Valve Handle Modification for HPS500 Log Splitter

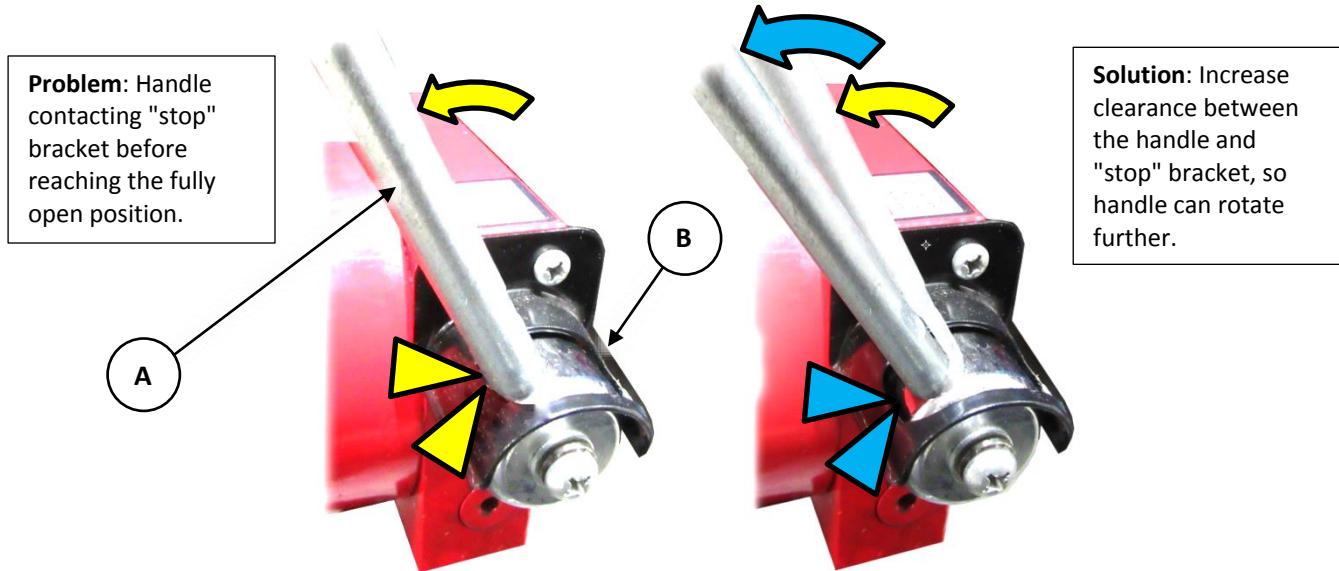
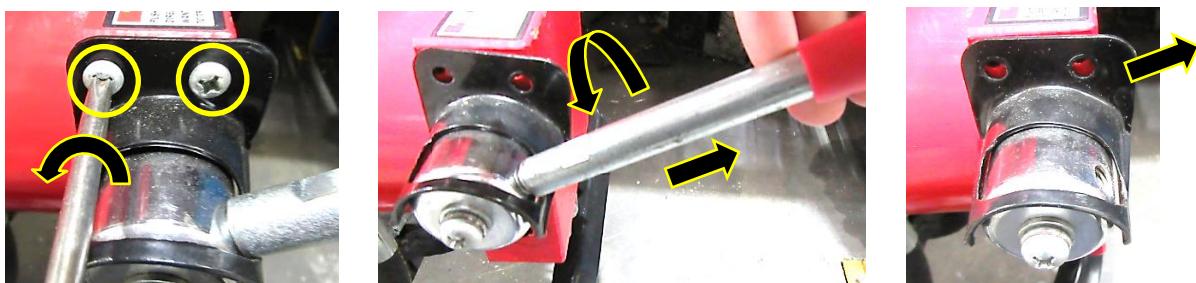
If the ram cycle time (time for ram to fully extend and retract) is noticeably slower than the stated time, it may indicate that the valve actuator handle cannot be rotated forward far enough to fully open the hydraulic valve. This may also be seen if the handle contacts the "stop" bracket when moved to the forward position. This is uncommon, but can be easily fixed.

5. Using either a suitable file or 5 or 6mm drill bit, enlarge the "stop" bracket mounting holes. OR, using a suitable file, increase the length of the slot in the "stop" bracket by **2 to 3mm**. The modification is to allow the "stop" bracket to be installed in a slightly forward / rotated position.

1. Ensure that the machine is OFF, and sitting on a flat and level surface.
2. Locate the 2 screws securing the "stop" bracket. Use a suitable screwdriver to remove the screws.
3. Unscrew the handle from the valve and remove it (a suitable spanner may be required).
4. Remove the "stop" bracket from the machine.

6. Reassemble the "stop" bracket and valve actuator handle. When doing so, keep the "stop" bracket as far forward as possible to provide maximum clearance between it and the handle.
7. Test the machine. If the handle still contacts the "stop" bracket, modify it further and re-test. If there is no change in how far the handle can be rotated or any noticeable difference in ram cycle time, contact customer service.
